SERVICE BULLETIN AMATEUR RADIO

SUBJECT	DATE
TS-940S SQUELCH SWITCHING NOISE	7-21-87

FIGURE 1

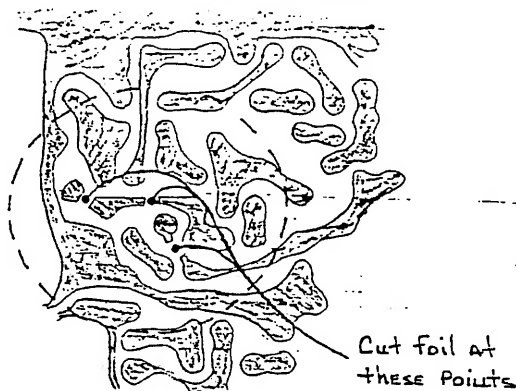
8. Using a small craft knife, cut the foil at the 3 points shown in figure 1 (top right corner of the board).
9. Unsolder and discard resistors R194 and R197. They are mounted on the component side of the board and soldered on the foil side.

FIGURE 3

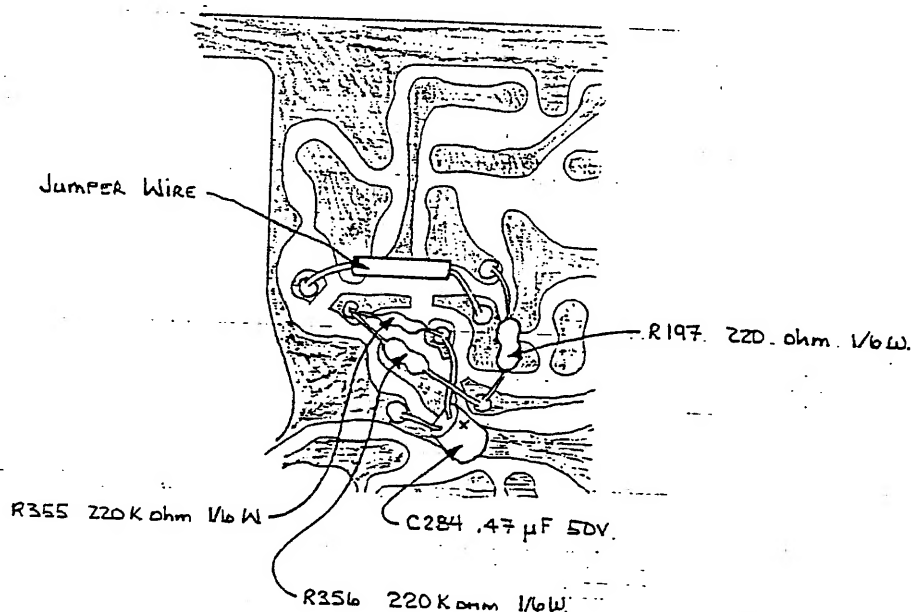
11. On the foil side of the board, add the 3 resistors (R197, 355, 356) as shown in figure 3.
12. Add a small jumper wire as shown in figure 3.
13. Add capacitor C282 as shown in figure 3. Observe polarity and insulate the positive (+) lead with shrink tubing.
14. Carefully place the board in its original position (do not pinch wires) and secure it with the 7 screws.
15. Plug in connector # 17. Move the 4 wires on the far side of the board back to their original position.
16. Put the covers back on the TS-940S and secure them with the 16 case screws.
17. Connect the antenna and power cord then test the transceiver for normal operation.
